February 26, 2016

02246 Version 3

Fluttering Noise From Behind Dashboard

Supersedes 15-042, Dated November 6, 2015; to revise the information highlighted in yellow.

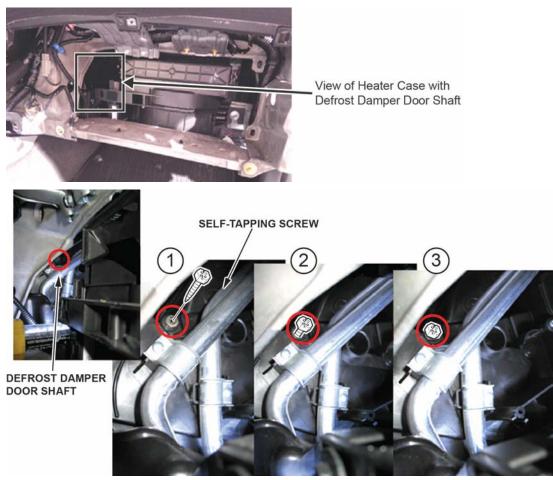
In step 3 of the REPAIR PROCEDURE, the illustration showing the self-tapping screw was revised to reflect the proper screw.

3. Install the self-tapping screw (P/N 90132-SR3-003), into the defrost damper door shaft on the passenger side of the heater case. Start the screw by hand to minimize the chance of dropping and losing it. Tighten the screw until the head is seated against the plastic heater case.

NOTE: Do not over torque the screw or you can damage the heater case.
